## ADDENDUM

**PROJECT:** South Dakota State University  
New Headhouse & Greenhouse  
Headhouse Shell Package  
Brookings, South Dakota

AD-1

**PROJECT #:** 12-0124 / OSE R0312-19X / SDSU 201202336

Drawing # S-001.1

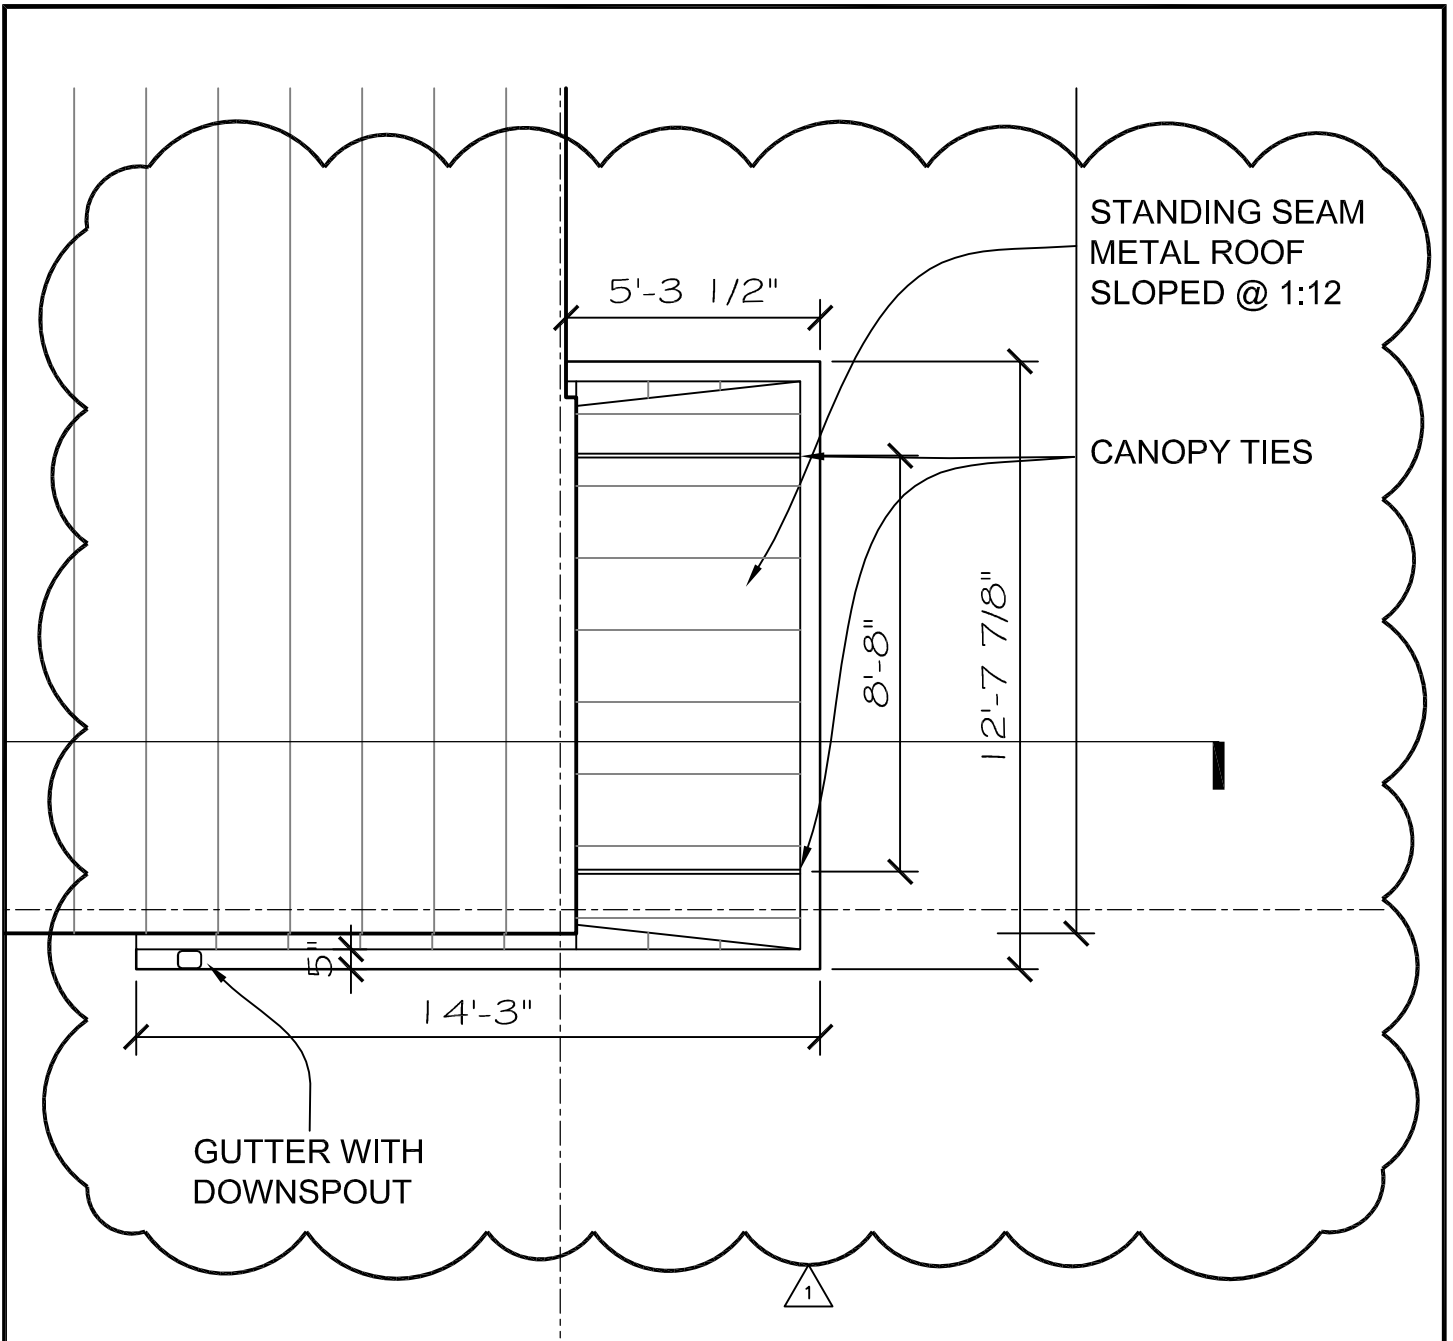
See attached 8.5 x 11 Supplemental Drawing S-001.1 showing revisions to Detail 1.

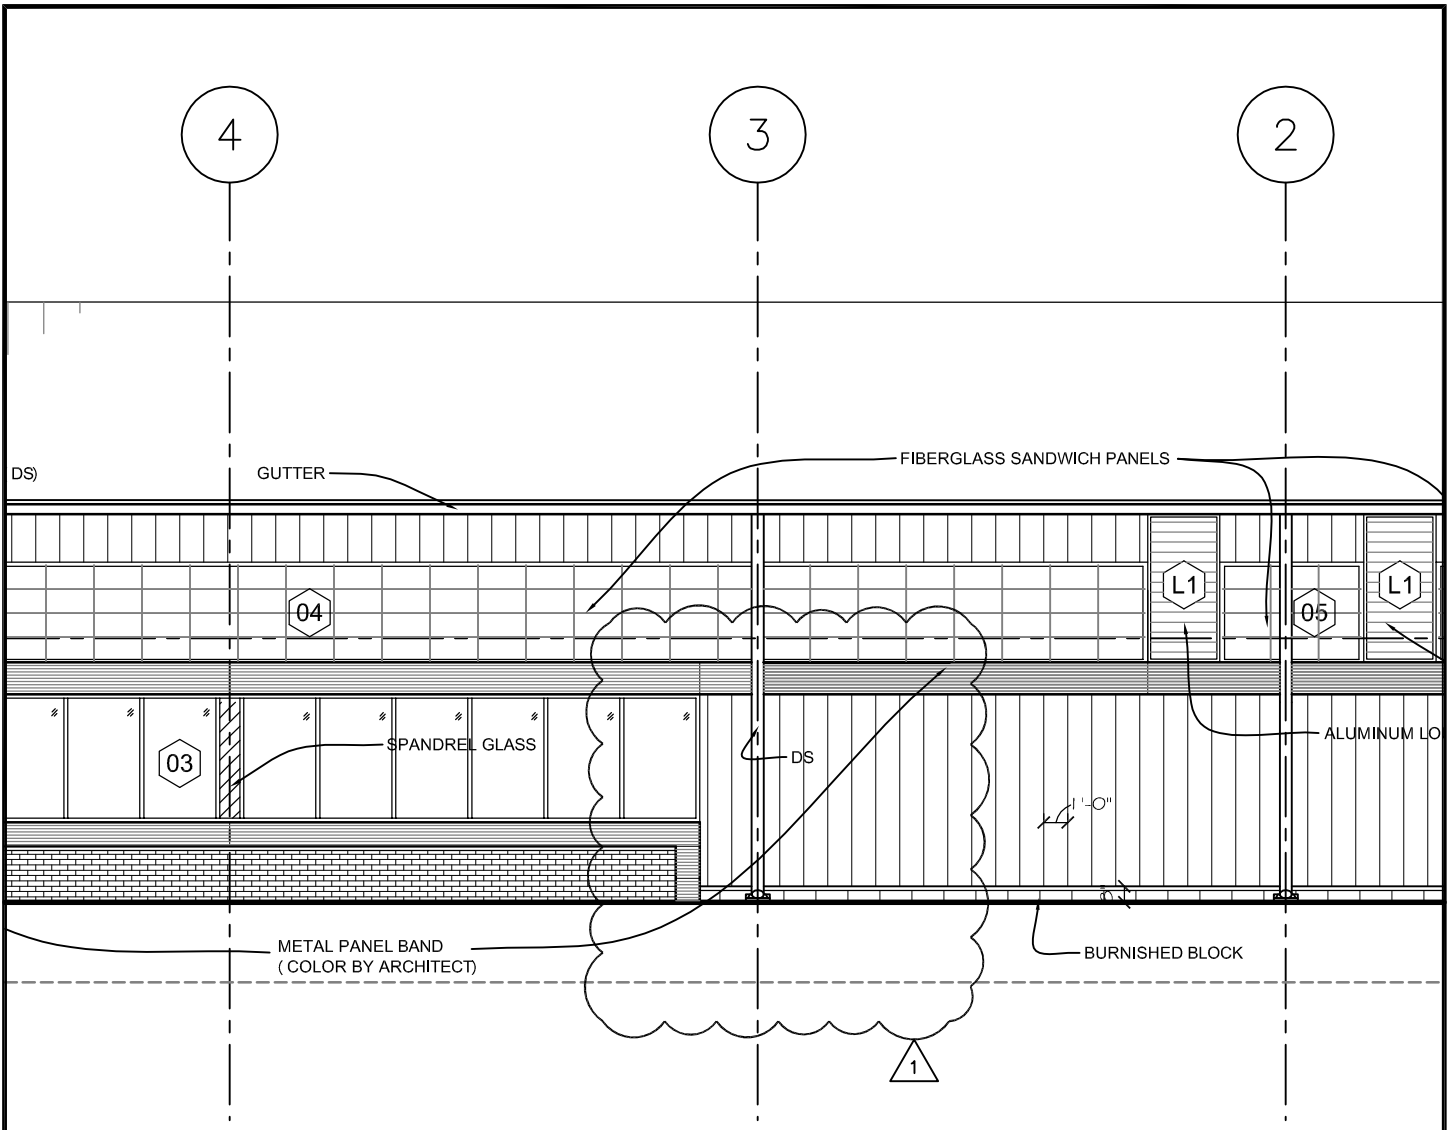
In reference to **Sheet A-103**, see attached 8.5" x 11" Supplemental Drawing A-103.1 showing revisions to roof canopy over Door 100A.

# 1 Partial North Elevation

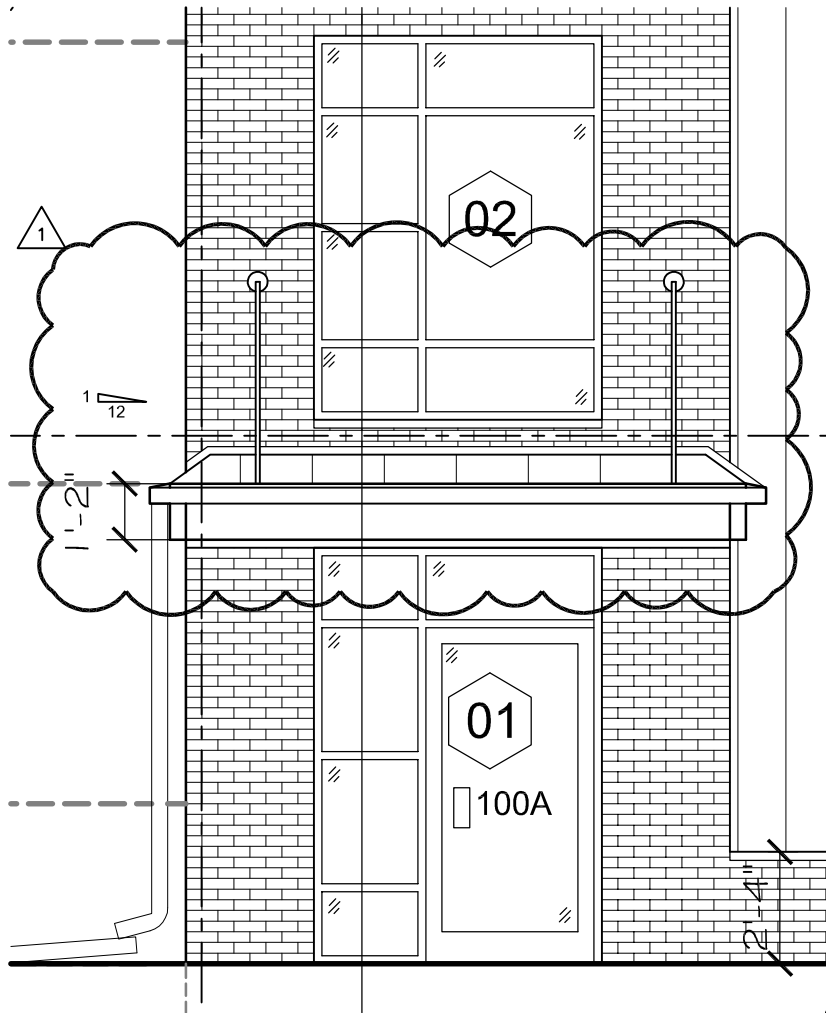
See attached 8.5" x 11" Supplemental Drawing A-201.1 showing revisions to the north elevation.

\*\*\*REMOVE SPANDREL GLASS AND FRAME ON EDGE OF GLAZING SYSTEM AND LINE UP EDGE OF METAL PANEL BAND WITH EDGE OF WINDOW

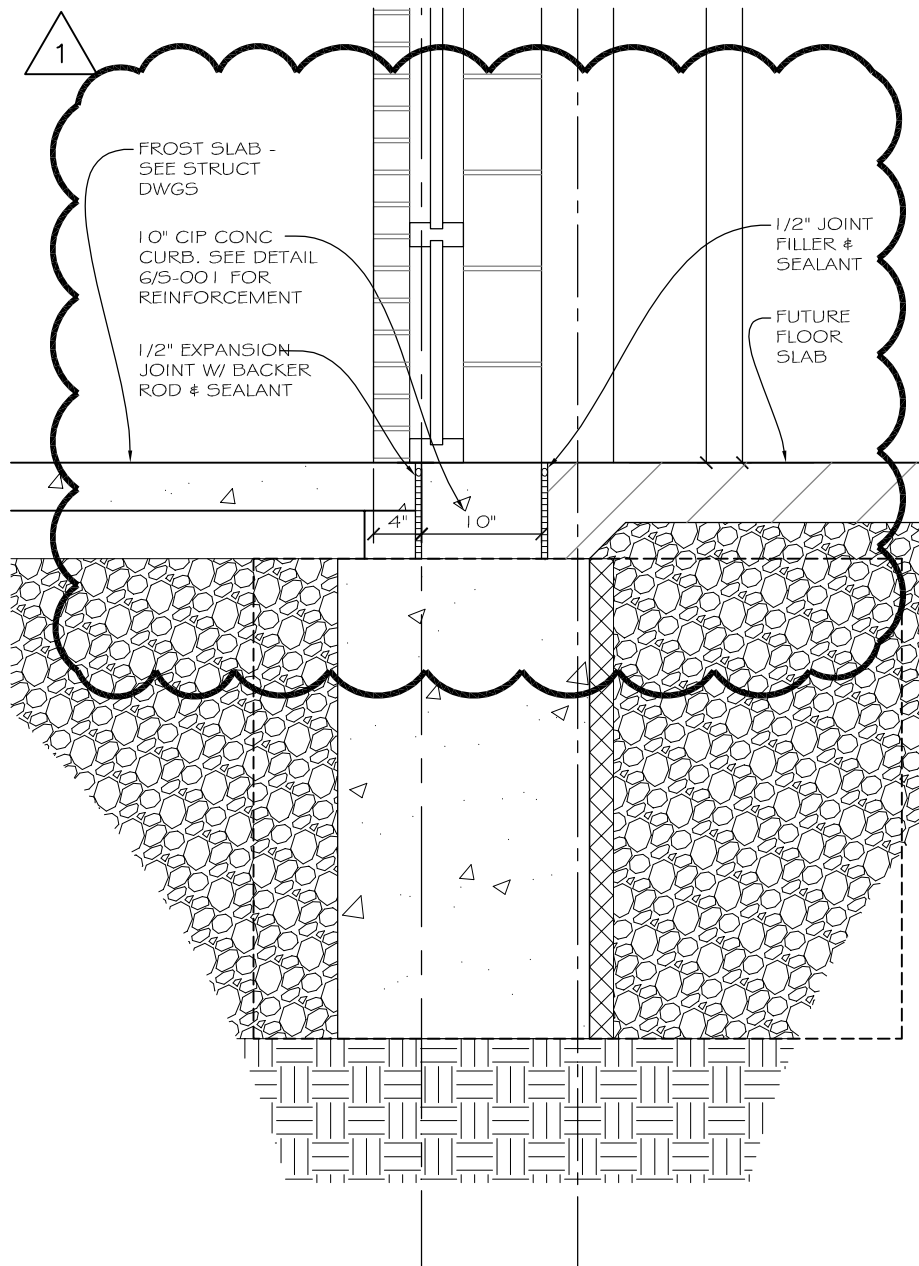
See attached 8.5" x 11" Supplemental Drawing A-201.2 showing revisions at the canopy or the east elevation.

Drawing #  
A-303.1

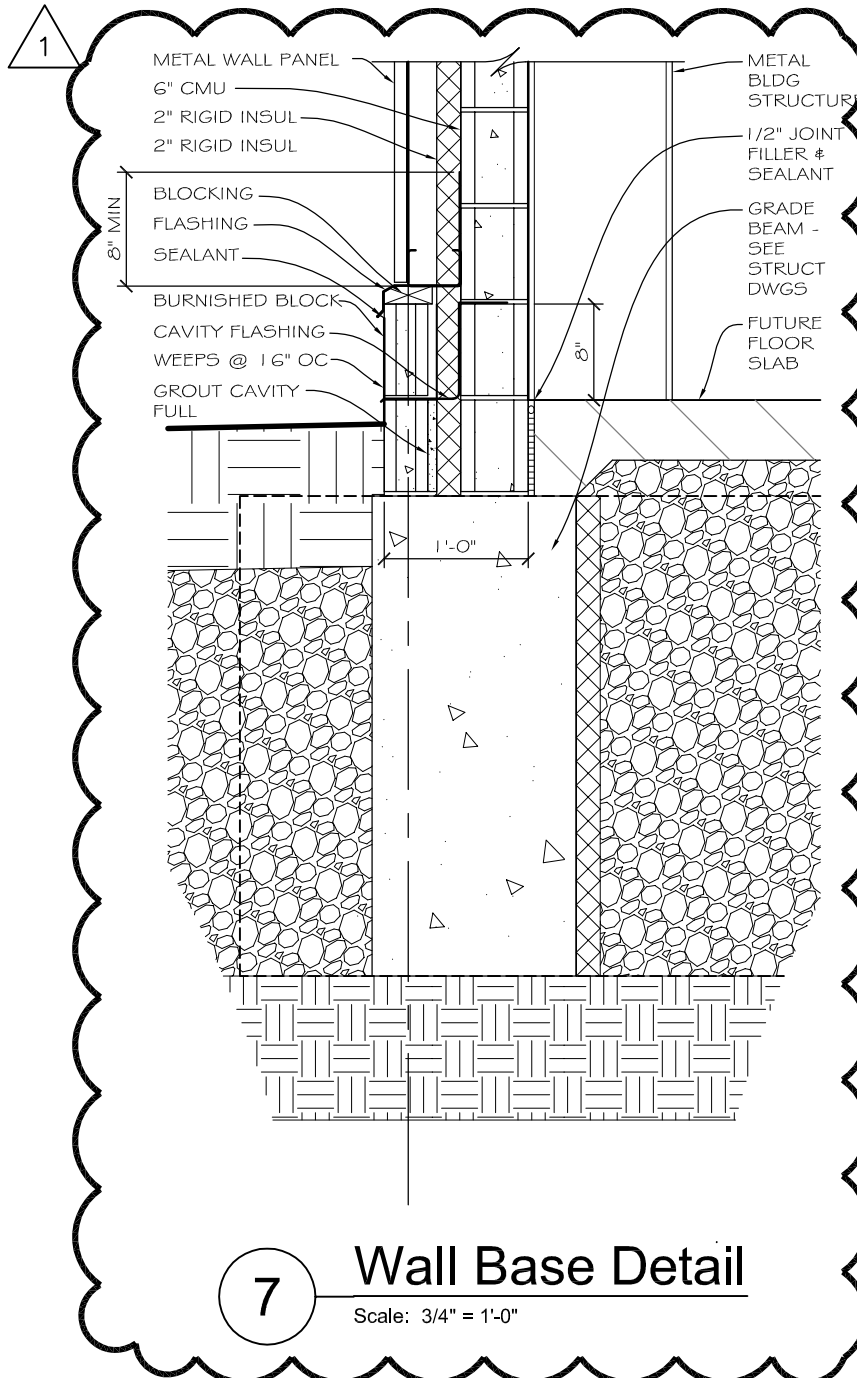
See attached 8.5" x 11" Supplemental Drawing A-303.1 showing revisions at the floor construction at Wall Section 5. Note: The cast-in-place concrete curb occurs only at door openings and window frames extending to the floor.

From Sheet: A-303	for CA use:
Drawing # A-303.2

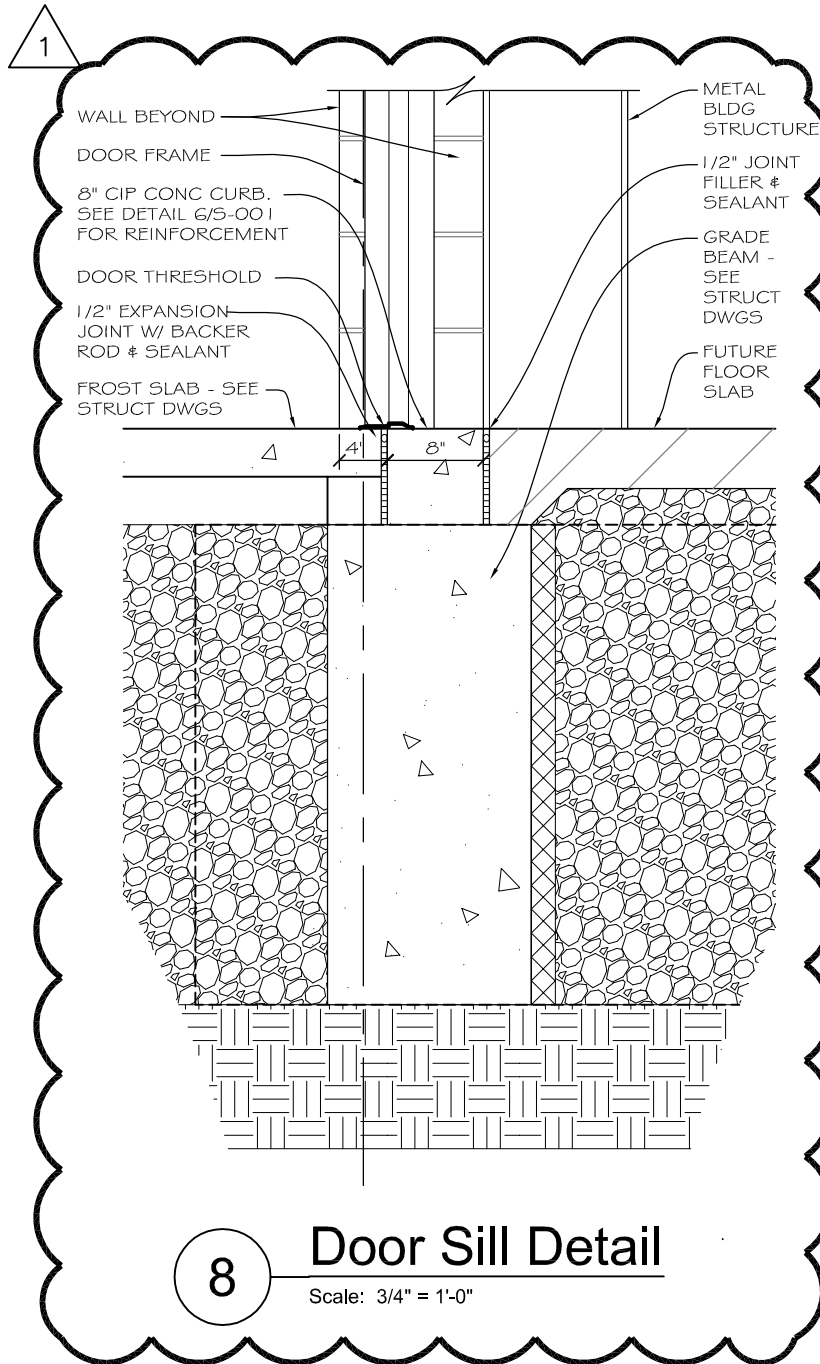
In reference to Building Section 2, delete the wall section reference 2/A-303 at Column Grid Line A and replace in the lower section of the same wall, detail reference 7/A-303 issued as a new detail in this addendum.

See attached 8.5" x 11" Supplemental Drawing A-303.2 showing new lower wall detail.

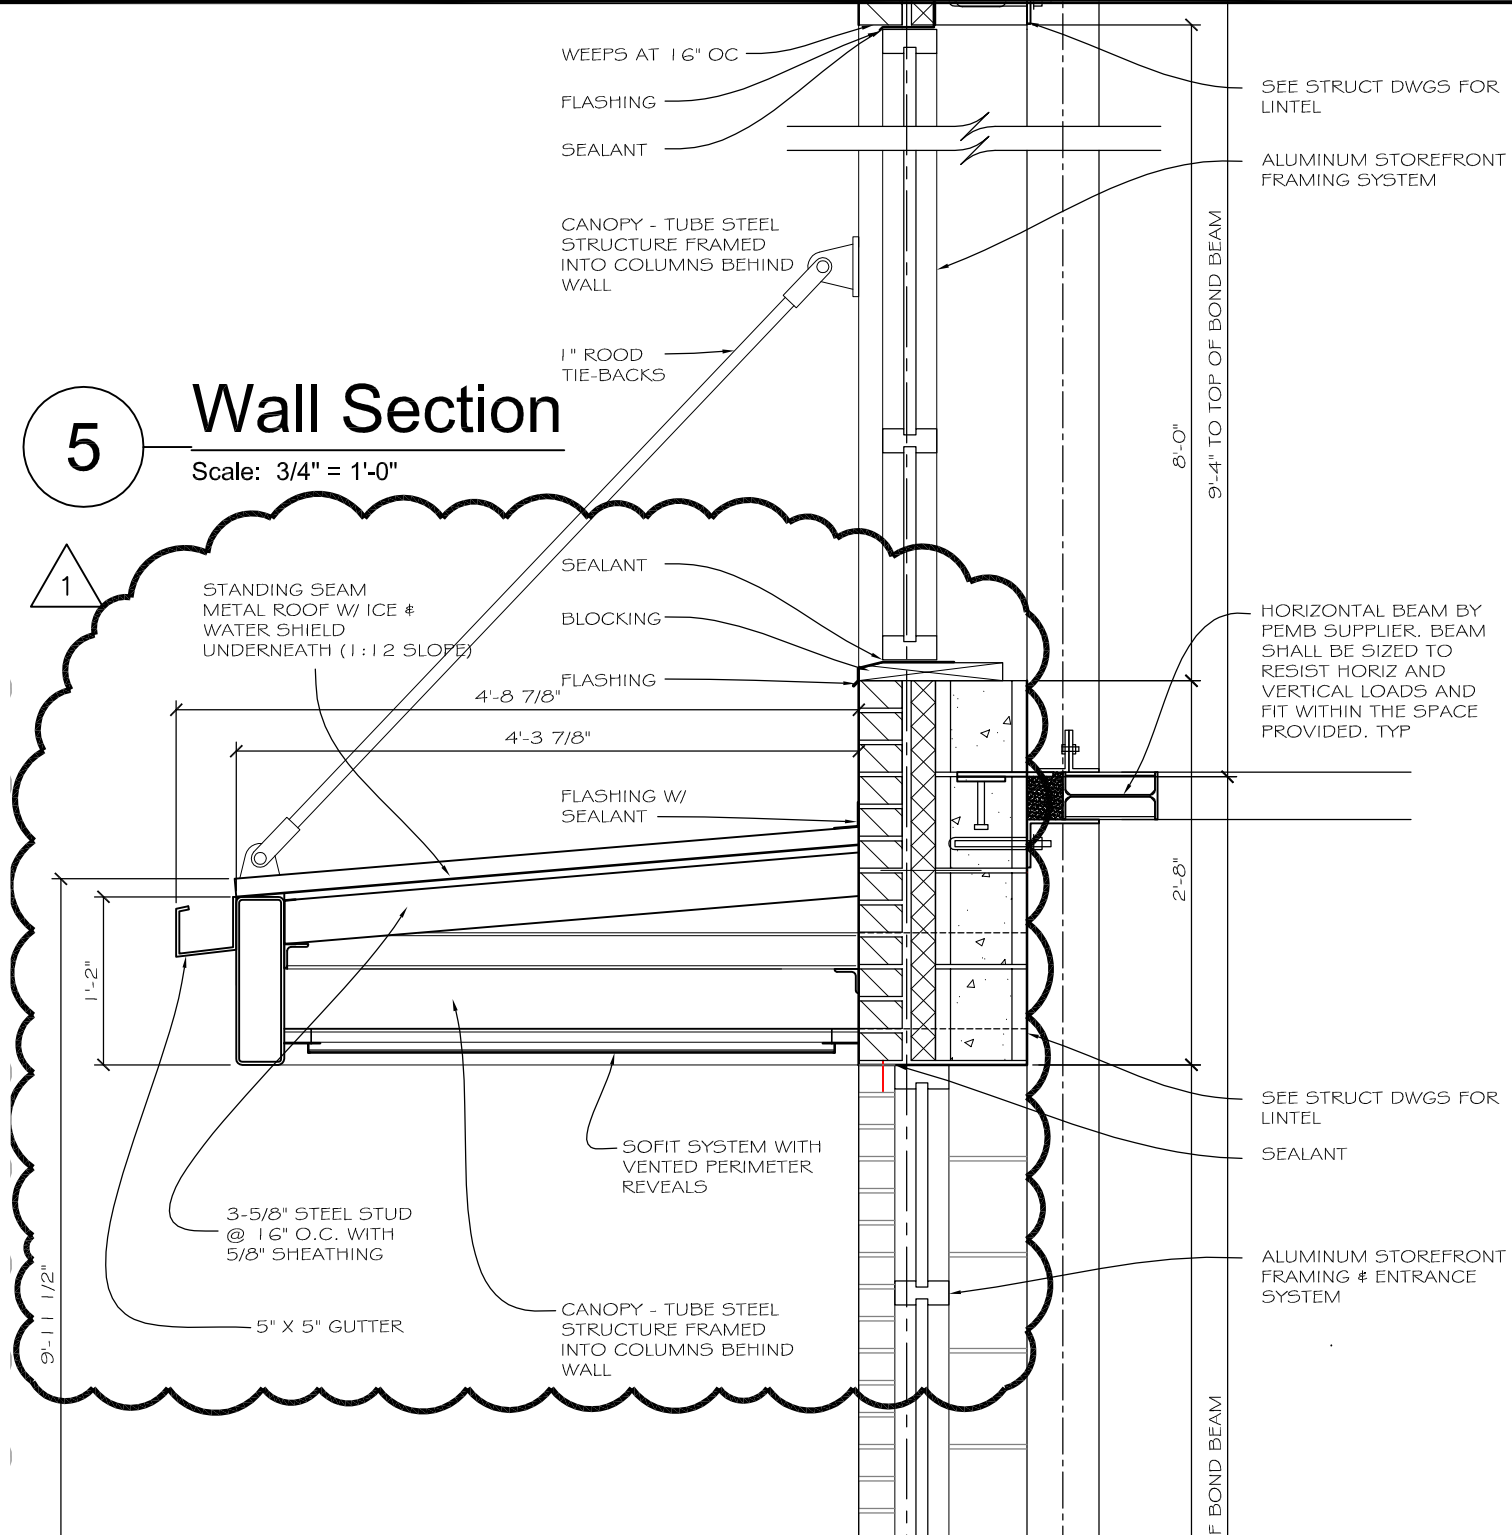
See attached 8.5" x 11" Supplemental Drawing A-303.3 showing new detail at door threshold.
